Bulletin No.: 14525-15036
Updated: May 2016

PRODUCT SAFETY RECALL

SUBJECT: Front Passenger Air Bag Inflator Replacement

MODELS: 2005 Saab 9-2X

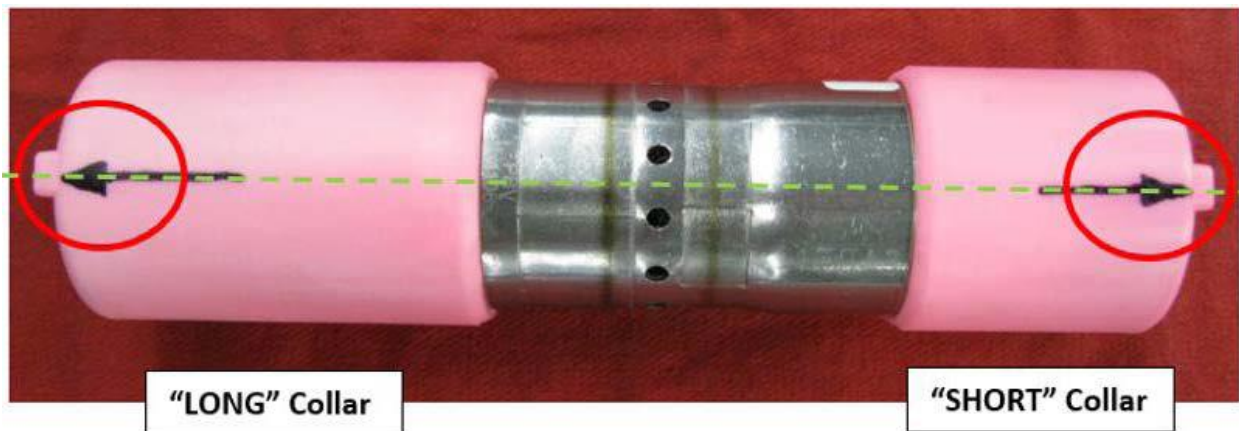
STEP 8- VERY IMPORTANT: Record the **11-digit alpha-numeric serial number for both the removed (Type 1) and 14-digit numeric serial number for the new (Type 2) inflator** on the Repair Order hard copy. This information will be required for completion of the Part Return Notice which will be forwarded by the retailer

STEP 9- Inspect the new **Type 2** inflator to confirm the locating protrusions on each of the pink collar portions are aligned as shown below. The “short” collar can be rotated as needed to align it with the protrusion on the “long” collar if necessary.

NOTE: The **Type 2** inflator is installed in the opposite direction of the original. This change puts the connector on the other end. The new harness has been extended approximately 2” to compensate.

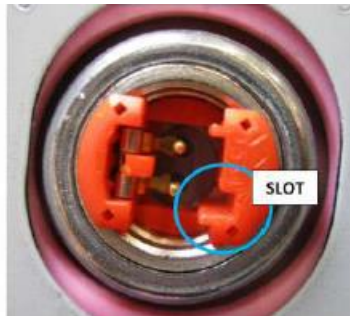
Remove the 2 nuts still installed on the mounting bracket and replace them with 2 **NEW** self-locking nuts. Once all 4 **NEW** nuts are in place, torque to 31 - 38 inch pounds in the new sequence shown below. Use a marker to mark the nuts after torquing indicating they have been fully tightened.
